Engineering Change Notification

This notice is to inform you of a change to the following LCD products:

NHD-C12864WO-B1TFH#-M
NHD-C12864WO-B1TGH#-M

NHD-C12864WO-B1TMI#-M
NHD-C12864WO-B1TTI#-M

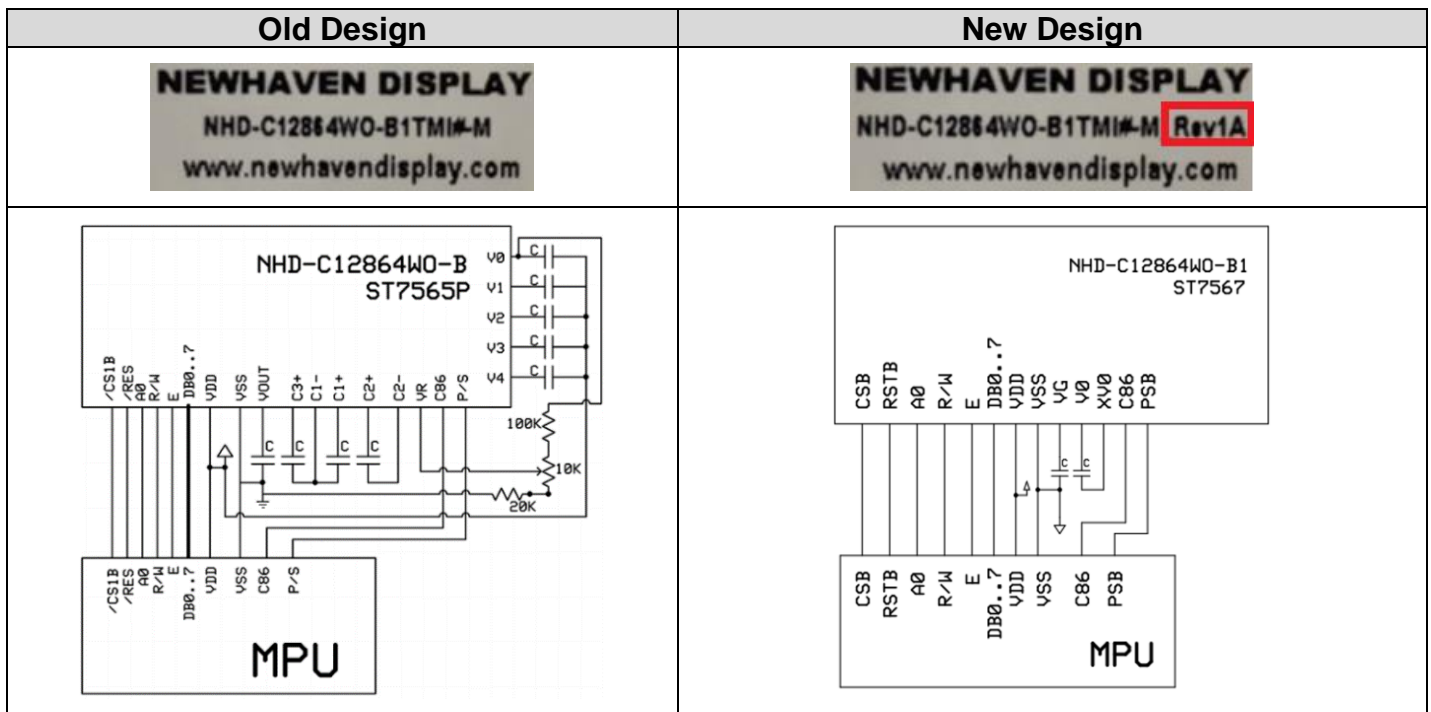
The ST7565P display controller used in these displays has been replaced by ST7567 controller IC. The display pinout has been modified to match the requirements of the new controller.

The new version requires a software change by the user to optimize display contrast. This can be done via the Set Booster command to configure the charge pump circuit.

The new displays will be labeled with a different revision control number after the part number. See example below.
